ADD2018-00062 Lee County ePlan

Re: Verandah -Administrative Amendment
ADD2018-00062

ADMINISTRATIVE AMENDMENT REQUESTS

SITE PLAN

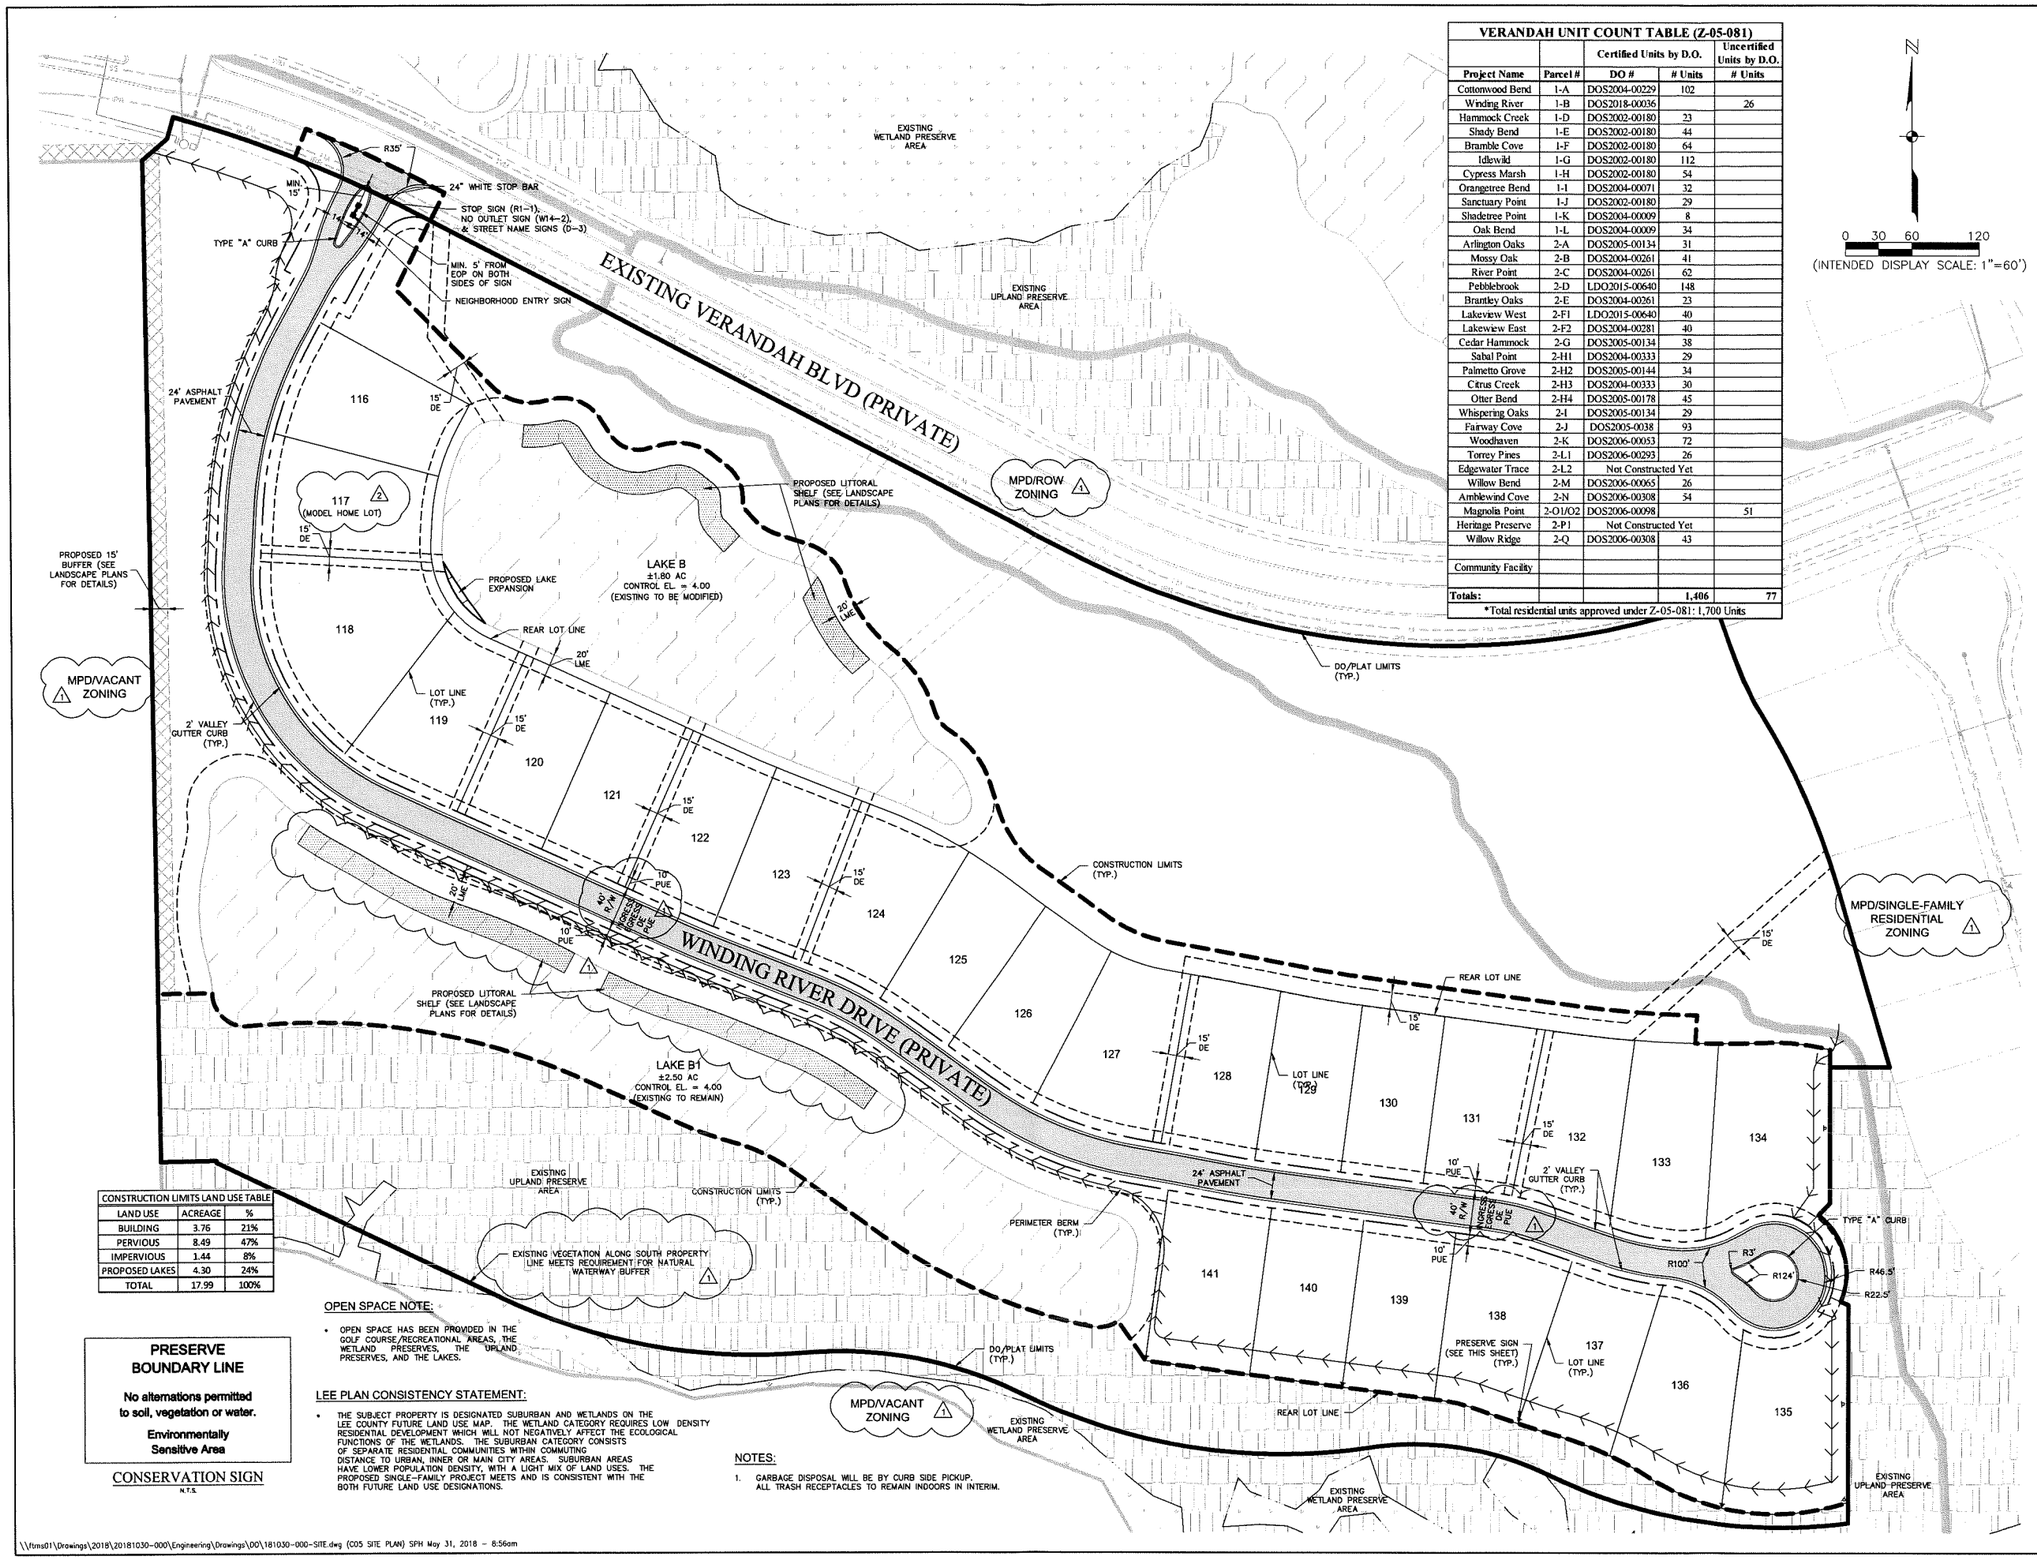
2. Request to revise the number of single-family homes from 21 (approved under ADD2008-00028) to 26.

The addition of five lots will not change the footprint of the existing development area configuration. The perimeter berm for this parcel was previously constructed and will not altered or affected by the proposed project. The currently proposed single family lots will be slightly reduced in width from the previously proposed lots, therefore allowing five additional lots to be constructed.

With the addition of the five parcels to this subdivision, the overall number of allowed units within The Verandah will not be exceeded. The attached Site Plan contains a Unit Count Table that depicts this information. The granting of this request will not adversely affect the public's health, safety or welfare.
